**SUBJECT: Wireless Telecommunications Facility Permit Application
(T-Mobile Site # LA33664E)**

SECOND NOTICE OF INCOMPLETENESS

Subject: Second Screencheck Comments - Wireless Telecommunication Facility Permit T-Mobile Site #LA33664E; W/O 10876 Culver Blvd

**ATTACHMENT 1
SECOND SCREENCHECK COMMENTS
WIRELESS TELECOMMUNICATION FACILITY PERMIT
T-MOBILE SITE #LA33664E – W/O 10876 CULVER BLVD**

SHEET TITLE:
SITE PLAN
AND DETAILS
SHEET NUMBER:
A-2

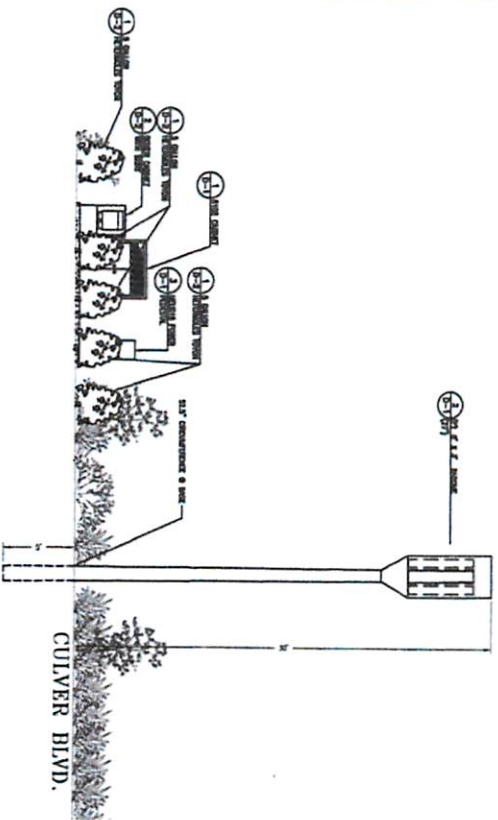
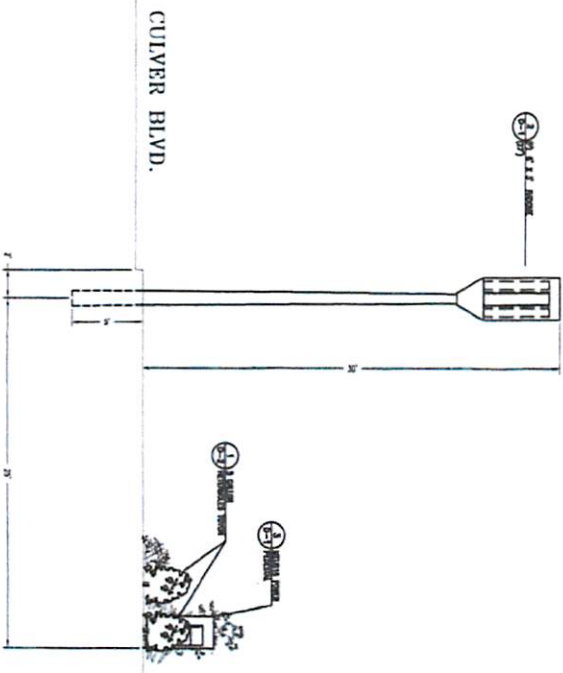
18. Label all existing utilities. See redlined plans.

19. Clarify if note #7 in the Placement and Construction Data section is referring to the same equipment as that which is referred to as the “fiber cabinet” shown on Exhibit F3 and the “boxer cabinet” shown on Sheet D-3 of the engineering plans. If so, provide consistent labeling in all exhibits.

Clarify if this is the "fiber cabinet" labeled in Exhibit F3; the "Boxer cabinet" on Sheet D-3. Provide consistent labeling.

Label any existing utilities.

CONCRETE
PAD

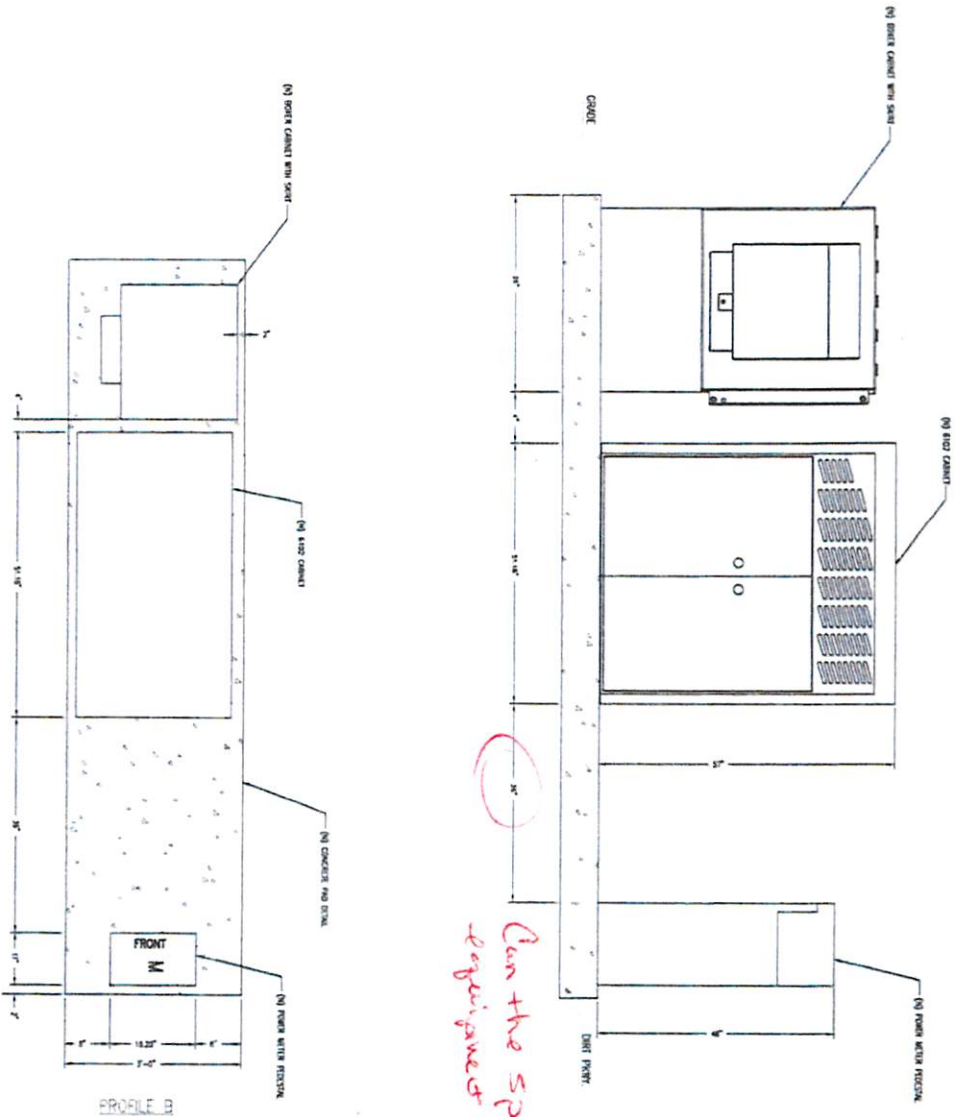
23. *2nd Request.* Decrease the size of the concrete pad to minimize the impact to the landscaped parkway. Provide clarification on why there needs to be so much space between the cabinet and the meter pedestal. See redlined plans.

Can the space between
equipment be minimized?
